**Agenda**  
**Plan Commission Public Hearing**  
**Followed by the Regular Plan Commission Meeting**  
**Town of Lisbon Town Hall**  
**Thursday, March 12, 2020**

Re: Kwik Trip Wexford Heights – Conditional Use Permit Application and Site Plan / Plan of Operation Review

The above-referenced Conditional Use Permit (CUP) application and associated Site Plan / Plan of Operation (SPPOO) were received in our office for review on behalf of the Town of Lisbon. A concept plan for the development was reviewed in December, 2019. We have reviewed the following application materials:

DRAWN BY S. ANDERSON / L. OLSON  
SCALE NOTED  
PROJ. NO. 119.1179.30  
DATE FEBRUARY 5, 2020  
SHEET SP 1.0

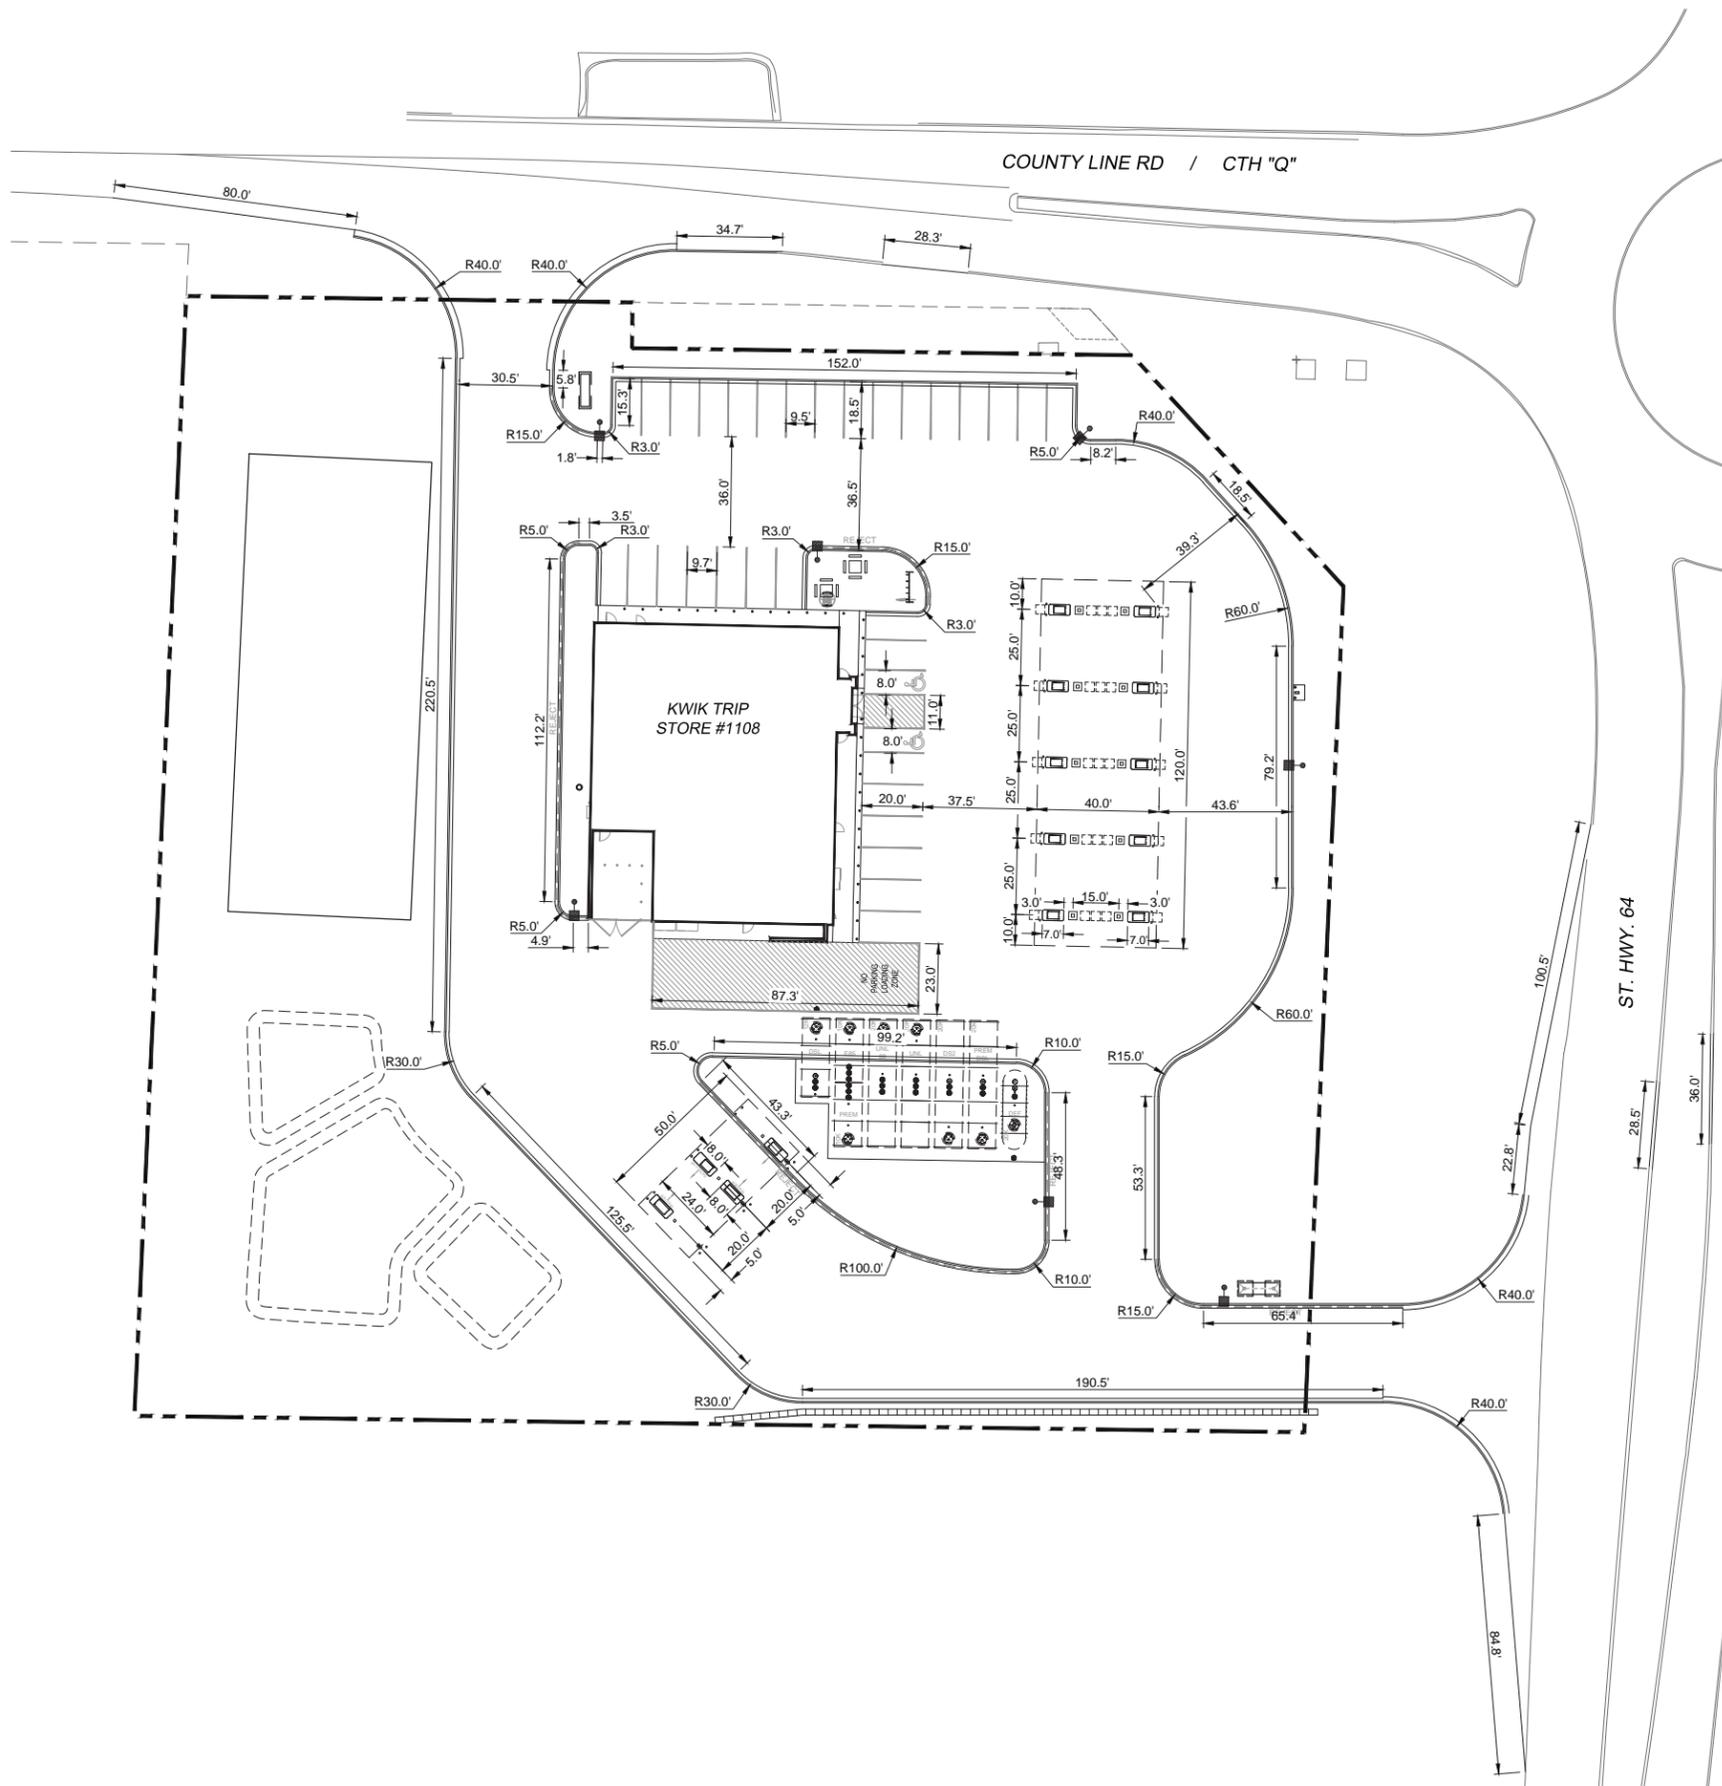
1. The Town Zoning ordinance requires 221 parking stalls based on 7,350 square feet of retail floor area. The applicant has shown an alternate parking plan for the establishment which is proposed as being adequate for similar establishments which they have constructed and managed.

2. The site plan provides more than the minimum one (1) loading space that are required by ordinance based on floor area.
3. Stormwater storage and drainage calculation will need to be approved by the Town Engineer.

4. Site plan sheets should indicate location of setback and offsets.
5. Lighting appears to comply with Town Code requirements that fixtures be hooded or beamed to eliminate glare, and pole lights comply with the maximum height of 18 feet. However, no pole height is indicated.

6. Sign approvals are to be handled at a later date with an application for a sign permit.
7. Fuel Canopies, as shown, encompass 4.4% of the total lot size, which exceeds the 3% maximum for accessory structures. The need for additional accessory structure lot coverage will need to be provided by the applicant and approved by the Plan Commission. The applicant wishes to exceed the maximum height of 15'. The code does not specifically detail heights for canopied structures. The need for additional canopy heights will be provided by the applicant and will need to be approved by the Plan Commission.

8. At least 15% of the site shall be set aside as open space. The site plan exceeds the standard with 38% pervious surface coverage.
9. A 30' wide green space shall be provided along County Highway Q and State Highway 164 ROW and shall include landscape plantings. The proposed site plan does not meet these standards. However, recent road improvements along Highway Q have been done within the existing Washington County has given preliminary approval on the access to the site along this arterial, showing no need by the County for more ROW for future for widening. The ROW along State Highway 164 is already at the 100' shown on the Waukesha County Street and Highway width map. Therefore, these green space standards will not be needed to accommodate future arterial widening at this site.

10. A 20' wide planted buffer shall be required along all property lines not adjacent to a parking area. Such buffer shall contain two (2) shade trees, six (6) evergreen trees, and 20 shrubs. The proposed site plan does not meet these standards. The need to deviate from these landscaping standards will be provided by the applicant and will need to be approved by the Plan Commission.

11. Parking facilities are required to be 30' from the County Highway Q and State Highway 164 ROW. The proposed site plan does not meet these standards. The need to deviate from these parking facility setbacks will be provided by the applicant and will need to be approved by the Plan Commission.

12. Commercial parking lots shall not be located in the street yard. The proposed site plan does not meet this standard. The need to deviate from this parking placement standard will be provided by the applicant and will need to be approved by the Plan Commission.

13. Retaining wall dimensions are required on the Site Plan, none are provided.

5. Show canopy heights.
6. Provide acceptable explanation for any canopy heights exceeding 15'.
7. Show lighting pole heights.
8. Provide acceptable explanation for any canopy heights exceeding 18'.

9. There shall be no outdoor storage of materials unless otherwise noted on approved site plans.
10. There shall be no trash or recycling stored outside of the building, except within a fully screened on-site dumpster/waste container, which must be shown on the final Site Plan.

11. Show setback and offset lines on plan sheets.
12. Show snow storage areas on site and landscaping plans.
13. Provide plans for ongoing maintenance of landscaping, including mowing and weed

14. Soil tests shall be done, and provided to the Town, to confirm the soils are buildable.
15. Provide acceptable explanation of any deviations from landscaping and parking standards listed in Addendum A – Chapter 12.
